Airways NZ Queenstown Airspace Petition Version 2

**Summary of Submissions Received, and Airspace
Designation Decision by CAA New Zealand.**

Indicative current and proposed Transit Lane areas in the Queenstown CTR

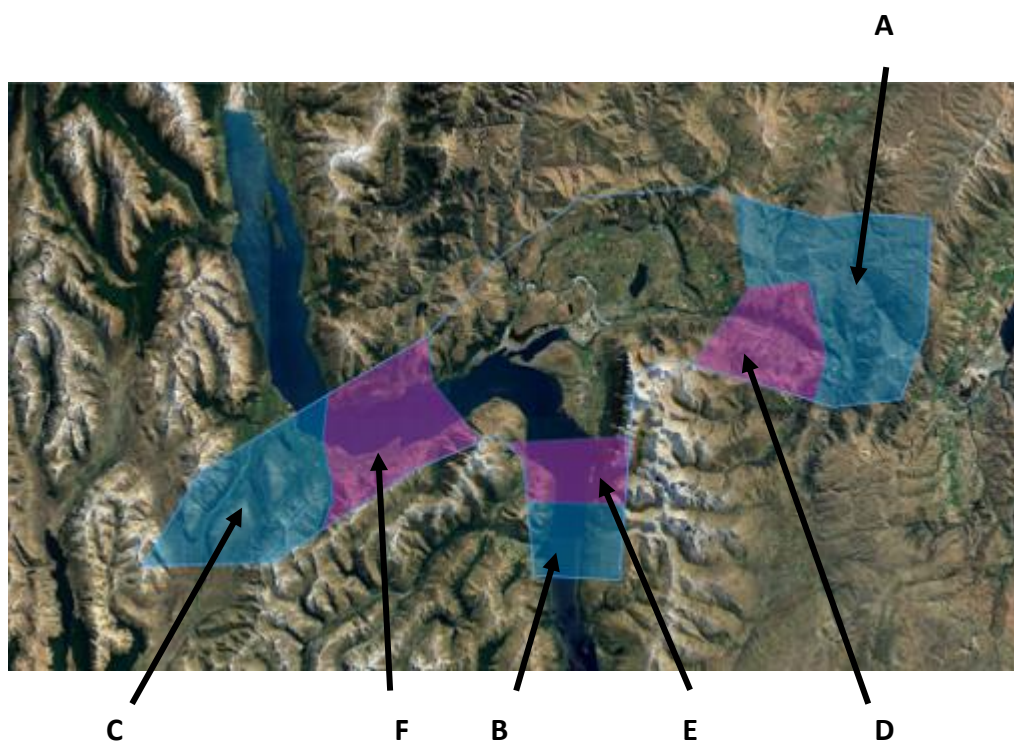
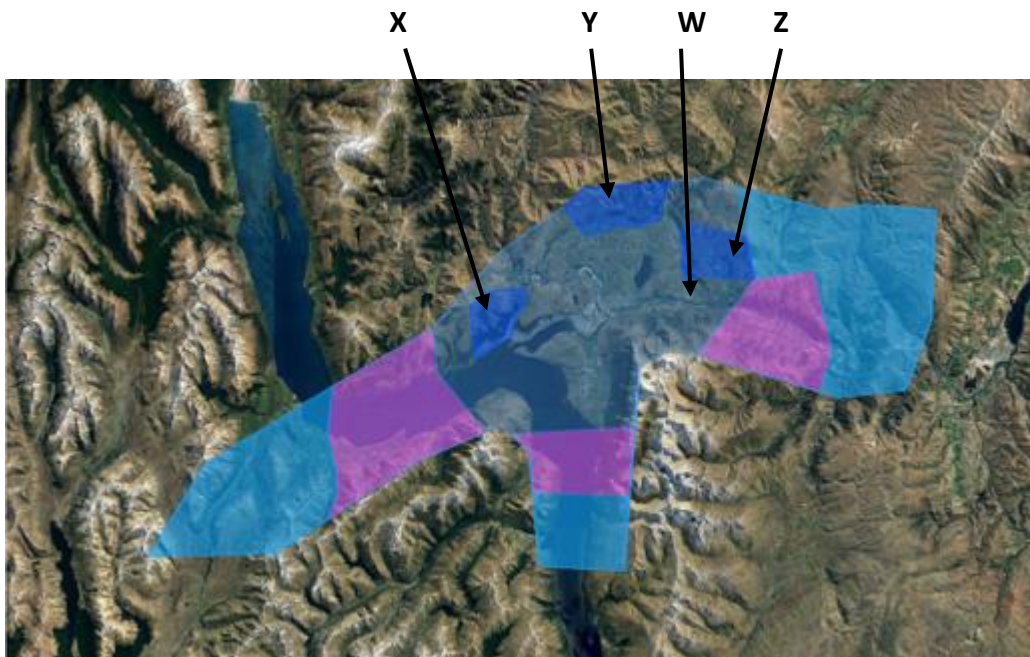
The proposed changes would approximately double the lateral extent of the VFR Transit Lanes. These would become Class G airspace during the day, and as such no air traffic service would be provided inside the transit lane, during daylight hours.

See indicative current and proposed Transit Lane areas in the Queenstown CTR are shown at Appendix B; in addition, the three current General Aviation Areas also within the CTR are depicted.
